## **Bellona Europa Feedback: Sustainable Finance – EU Classification System for Green Investments**

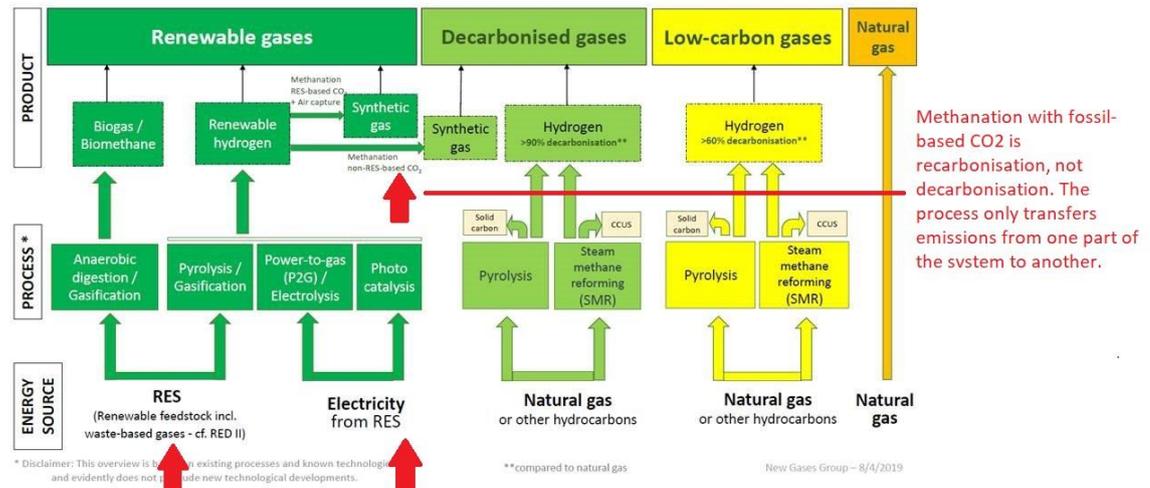
The illustration below was [presented](#) by a group of gas company federations<sup>1</sup> during the last Madrid Forum, providing their view on how renewable, decarbonised and low-carbon gases should be defined. However, as our comments in red point out, the climate impact of these

categories of renewable and decarbonised gases is highly questionable and could easily result in emissions of fossil GHGs to the atmosphere.<sup>2</sup>

Waste based gases are not a renewable feedstock. E.g. blast furnace gas has the biggest GHG footprint per TJ of energy produced (259.4 tCO<sub>2</sub>/TJ - in comparison, natural gas is 56.1 tCO<sub>2</sub>/TJ) Another example would be the use of syngas from pyrolysis/gasification of plastic waste. Not only would this prevent actual GHG reductions by discounting the emissions as 'waste', but it would disincentivize reduction&recycling of the waste in question.

The electricity input needs to be entirely renewable. E.g. if PtL/PtG is produced with the current German grid mix, the fuels have a footprint >330 gCO<sub>2</sub>/MJ (for comparison, fossil diesel: 94,1 gCO<sub>2</sub>/MJ)

We cannot allow for overestimated potentials of a broad category of ill defined 'low-carbon' gases to justify the further development of already existing gas infrastructure when it is not in line with European Green Deal, the climate target of net-zero by 2050 - and certainly not part of the "Gold standard" set by the Taxonomy to incentivise investments into sustainable economic activity. The Taxonomy should primarily support grid expansion, interconnection and distribution and forego new investments in the gas sector or any equivalent fuels with a questionable climate impact. If any additional transmission and distribution networks are supported, they should be dedicated specifically to the transport of low-carbon hydrogen, low-carbon ammonia and blending with fossil gas should be avoided.
